MONTGOMERY COUNTY PLANNING DEPARTMENT
THE MARYLAND-NATIONAL CAPITAL PARK AND PLANNING COMMISSION

MEMORANDUM

SUBJECT: Special Exception Request (S-2743: Henderson Corner & 355, LLC)

ATTACHMENT 2A

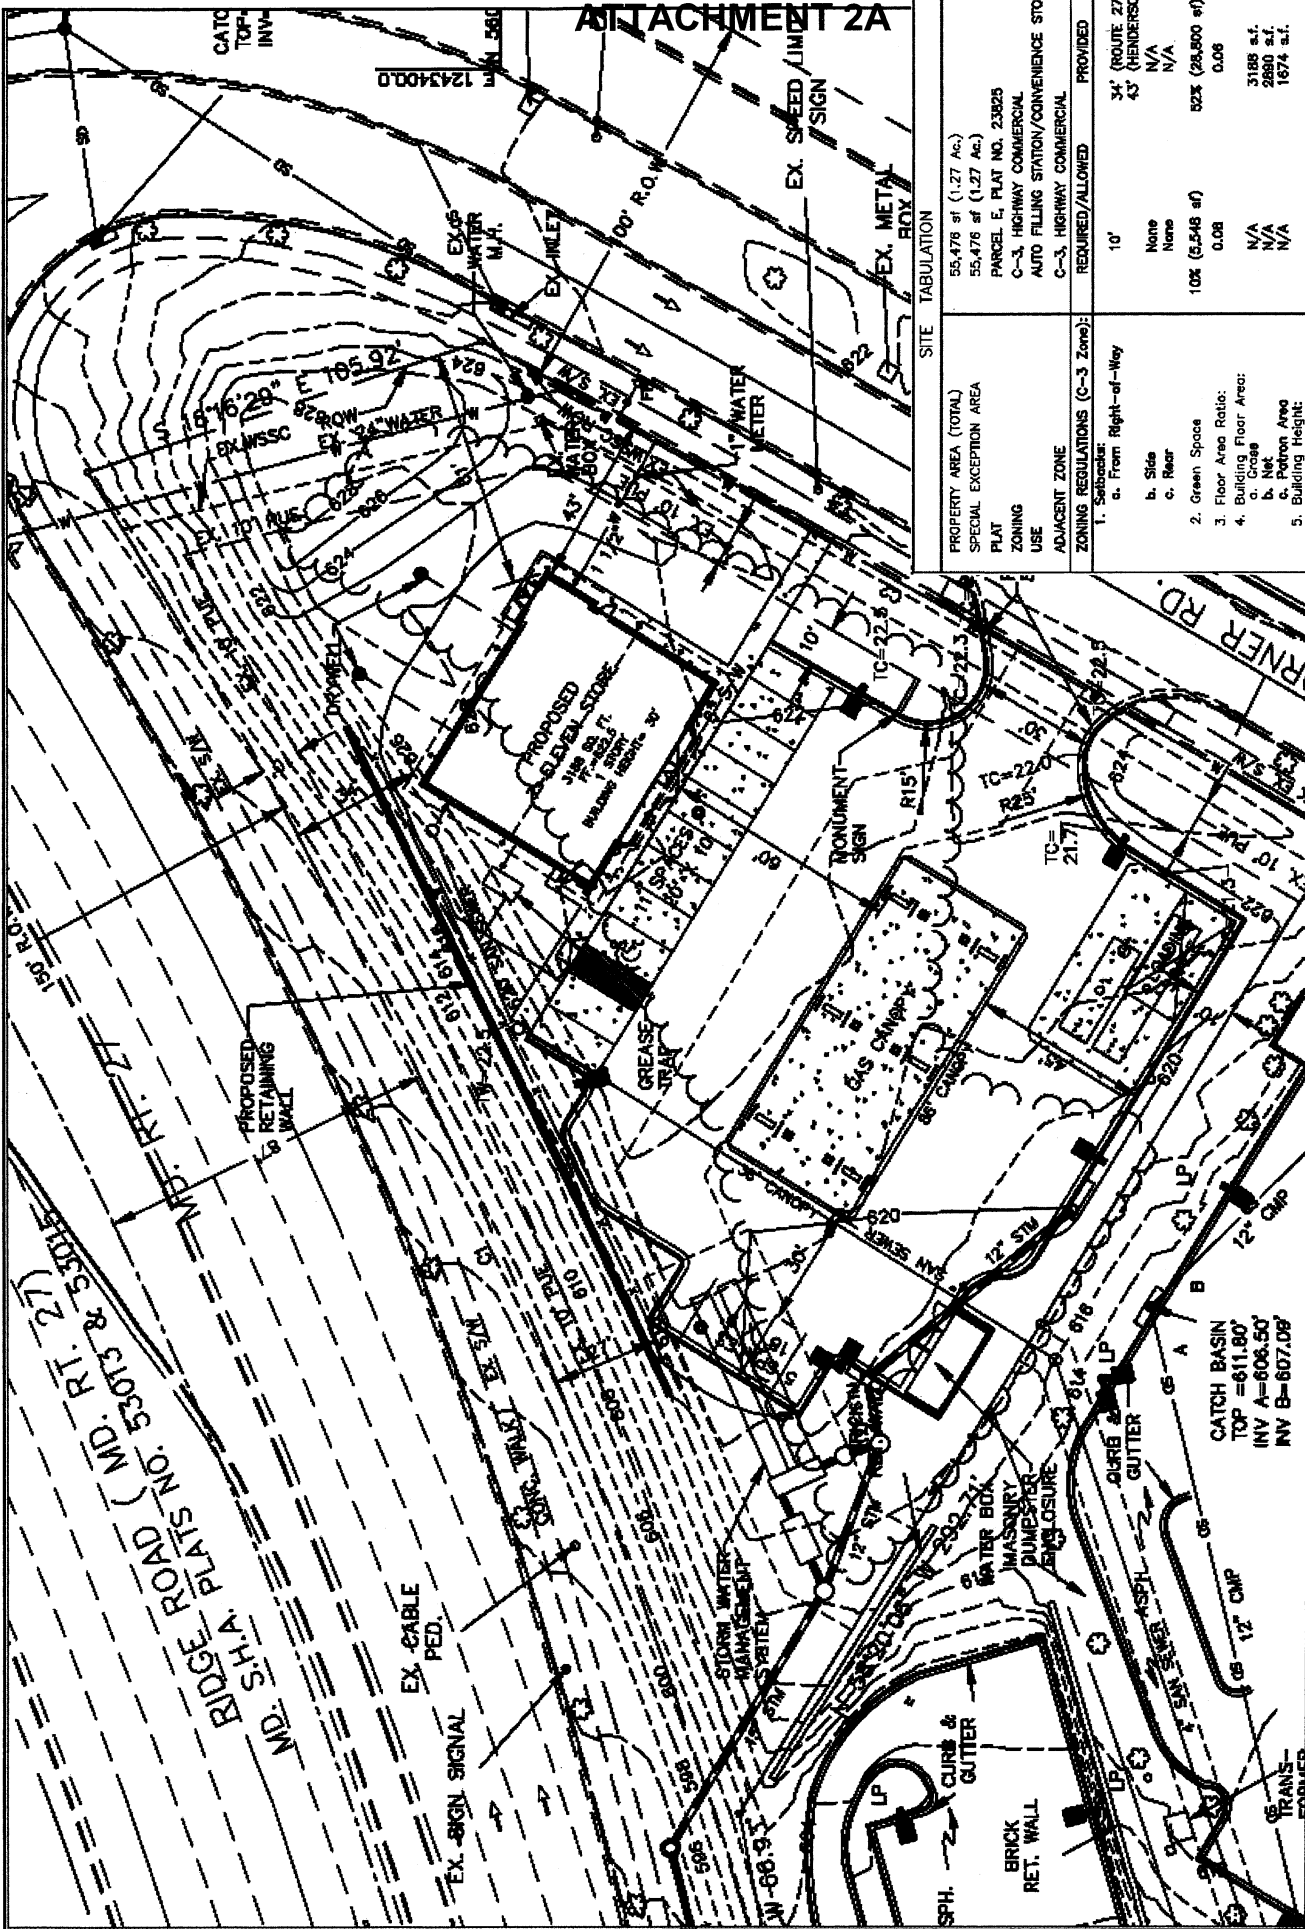
The core improvements are the construction of a filling station, including 12 pumping stations and a convenience store. Sixteen parking spaces are proposed and a masonry dumpster enclosure will be located on the southwest corner of the property. The proposed driveway would be located on the southeast side of the property, along Henderson Corner Road, approximately 340-feet south of its intersection with Ridge Road/MD 27. Turning movements are limited to right-in and right-out, and a left-in provided for north-bound access to the site. No access to the site is provided from Ridge Road/MD 27. (See Attachment 2A.) The proposed driveway access and left turn lane are consistent with the approved and recorded Preliminary Plan #120061210.

The applicant's plans call for a 36-foot wide by 86-foot long by 18'-6" high canopy (14'-6" clearance height) to cover the proposed pumping stations. A retaining wall is proposed at the northwestern side of the property. No carwash or service bays are proposed; however, two underground storage tanks will be located on the southeastern-most corner of the site,

5. A maximum canopy clearance height of 14'-6" and a total canopy height of 18'-6".

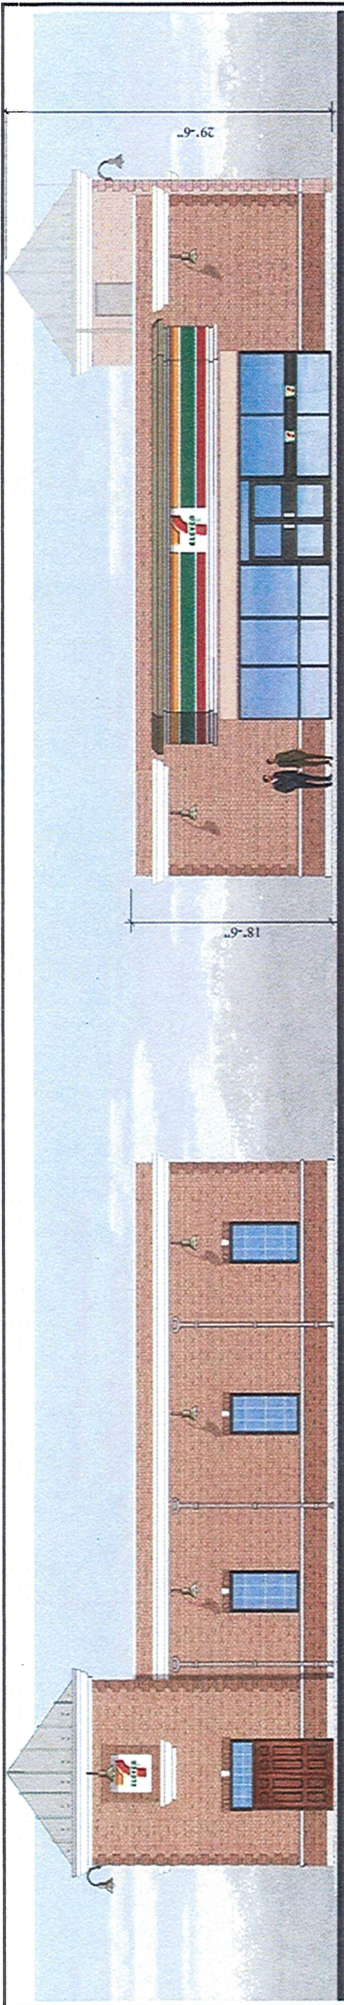
adjacent to Henderson Corner Road. Also on-site will be a 3,188 square feet, single-story building, which will include a 1,674 square foot convenience food, beverage and customer sales area. The remainder of the building will be devoted to office and storage use. (See Attachment 2B.) A tower-like feature has been added as a design element to the convenience store.

Staff Analysis: The proposed special exception use will be in harmony with the general character of the neighborhood considering the population density, design, scale and bulk of the structures, intensity and character of activity, traffic and parking conditions and number of similar uses. The site is one of several parcels located on a triangular piece of land that is surrounded on three sides by roadways. Two of these roads, Ridge Road and Frederick Road, are major arterial roads with rights-of-way greater than 120-feet. The traffic associated with this proposal will be 27 less trips in the P.M. peak hour travel times than the previously approved bank. In addition, the proposed height of the building is significantly lower than the permitted height of the zone and the building materials are similar to the surrounding area.

4' X 4' ILLUMINATED WALL SIGN

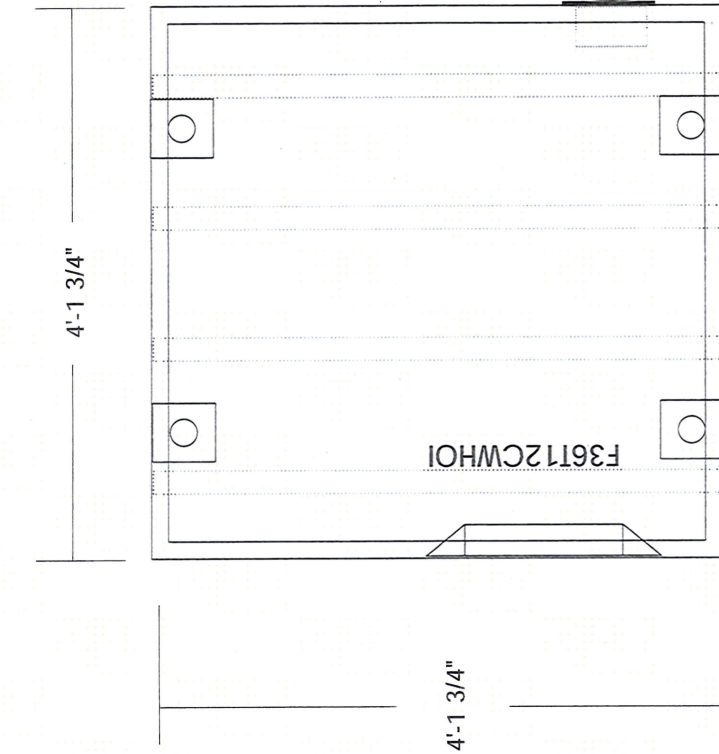
The applicant is proposing a 10-foot high, 27-inch wide monument sign, canopy signs and wall signs, which will be located on the upper face of the convenience store. (See Attachment 2C.)

Staff Analysis: The applicant is proposing one monument sign, at the driveway entrance to the site. The sign's area is approximately 49.5 square feet and is 10-feet high from grade and 27-inches wide at the base. The monument sign will be illuminated from the interior. In addition, the applicant is proposing four, 4-foot by 4-foot wall signs. Two of the wall signs are located on the tower (one on the north side and one on the east side), the third is proposed on the entrance to the convenience store and the fourth is proposed on the gas canopy. According to the information submitted by the applicant, these signs will be illuminated from the sign's interior. The proposed satisfies the Article 59-F requirements.

ATTACHMENT 3

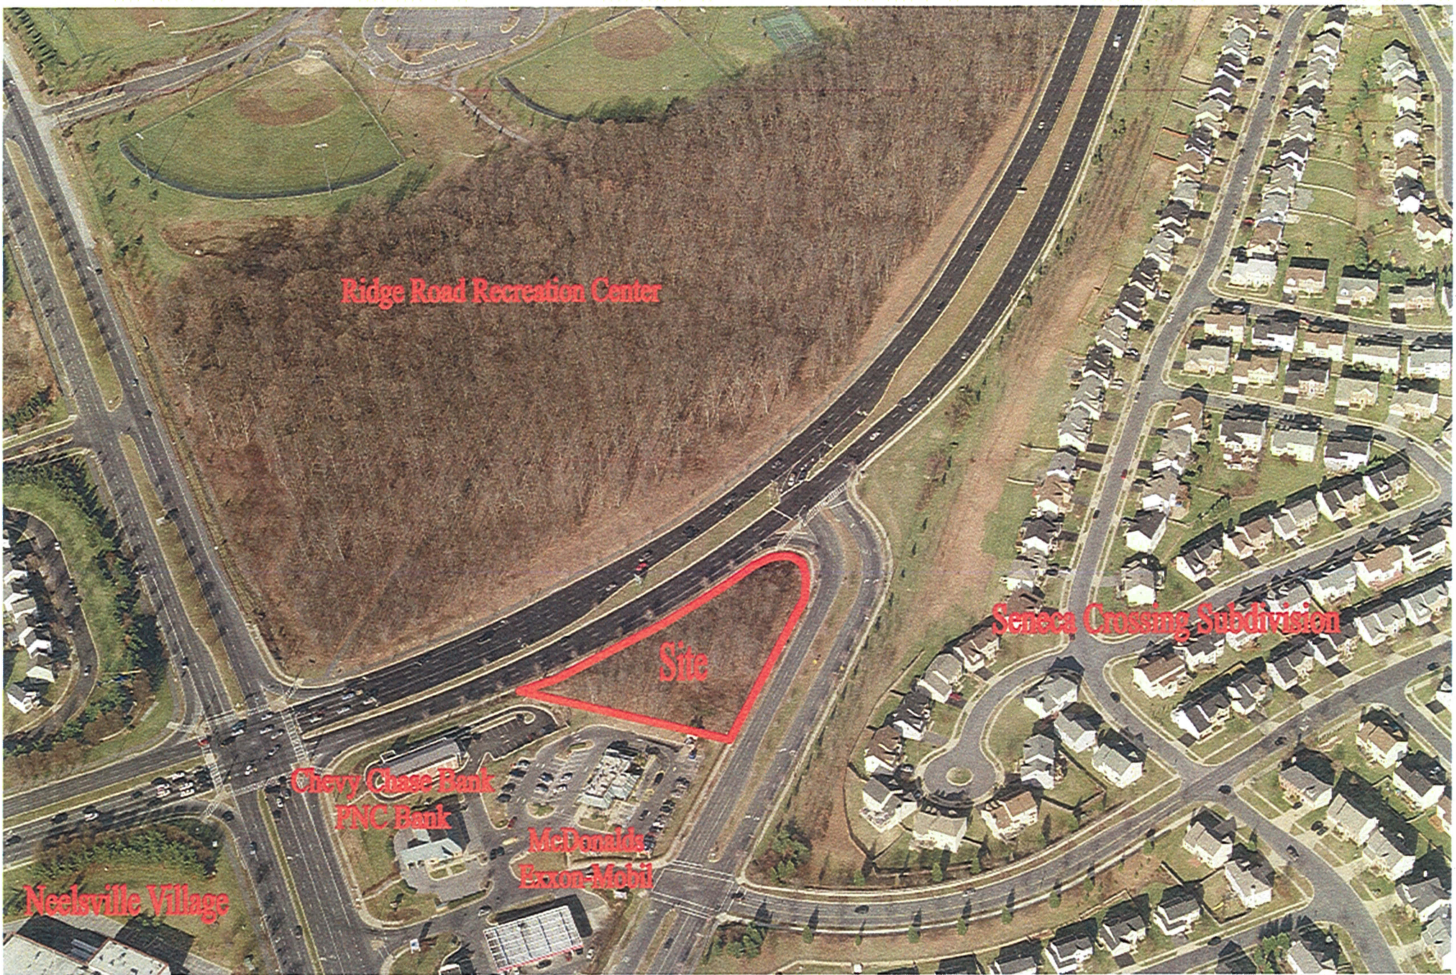
The site is approximately 1.27 acres in size and is primarily a wooded lot. The site has unusual grades that make the site higher than the surrounding properties and roadways. The lot is somewhat triangular in shape and is bounded on two sides by roadways. Midway along the Henderson Corner side, the property rises several feet to form a plateau, while the side of the property adjacent to Ridge Road/MD-27 slopes steeply downward to the roadway. Currently, there is no access to the site. (See Attachment 3.)

Staff Analysis: The proposed use will not cause any objectionable noise, vibrations, fumes, odors, dust, illumination, glare, or physical activity at the subject site. The natural vegetation, proposed landscaping and topography will restrict the visibility of the physical activity to the residential properties lying approximately 200-feet southeast of the site. (See Attachments 3 and 5.)

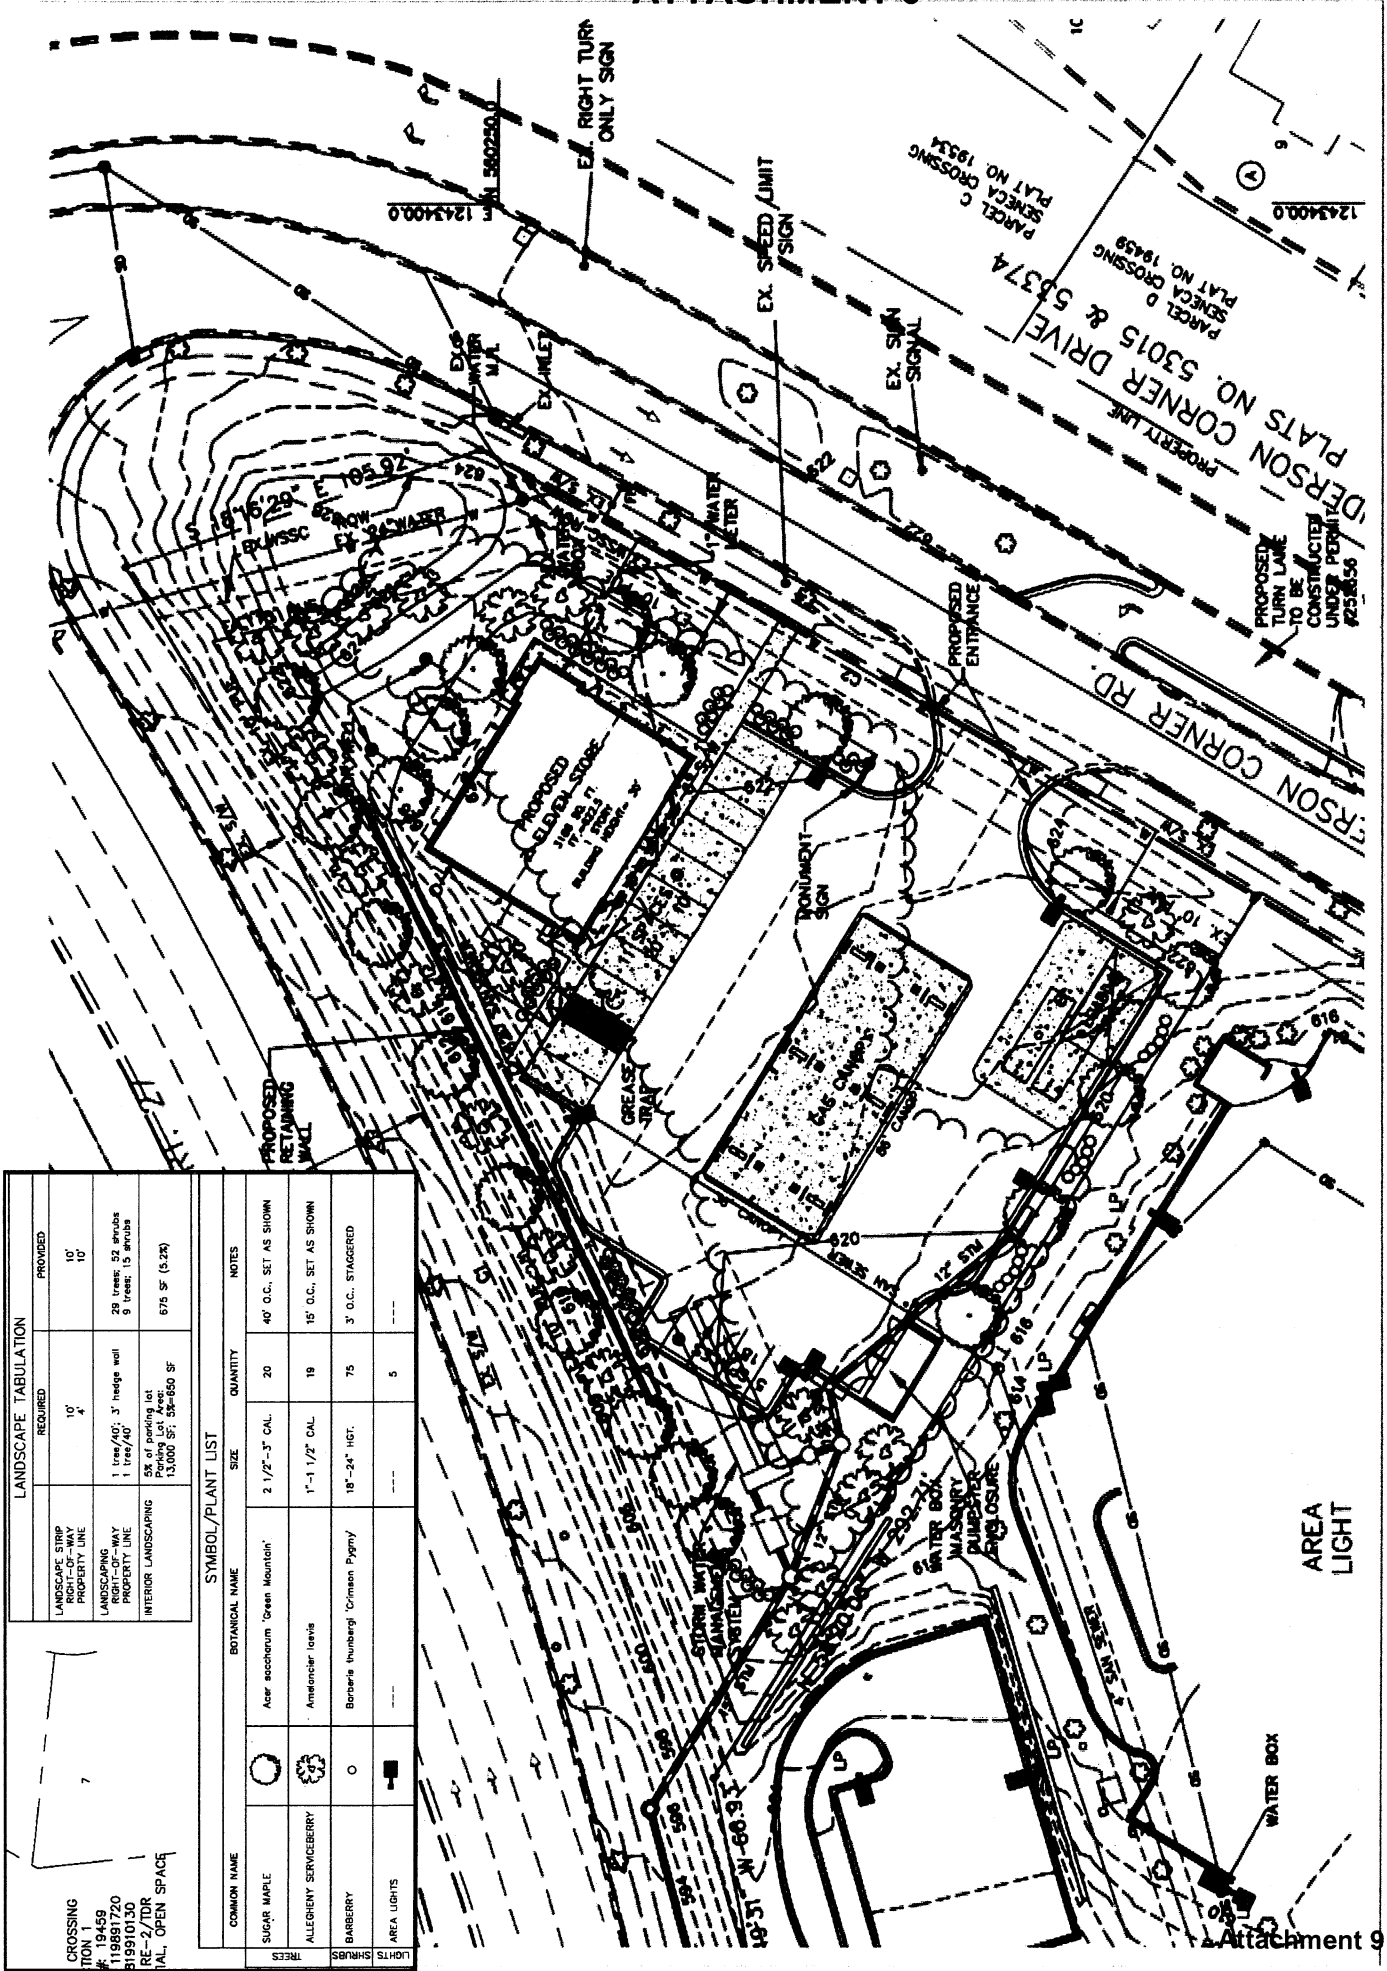
The applicant is proposing twenty-nine trees and fifty-two shrubs along the rights-of-way and nine trees and fifteen shrubs along the property line consisting of Sugar Maple and Allegheny Serviceberry trees and Barberry shrubs.

The filling station application satisfies the Article 59-E requirements. (See Attachment 9.)
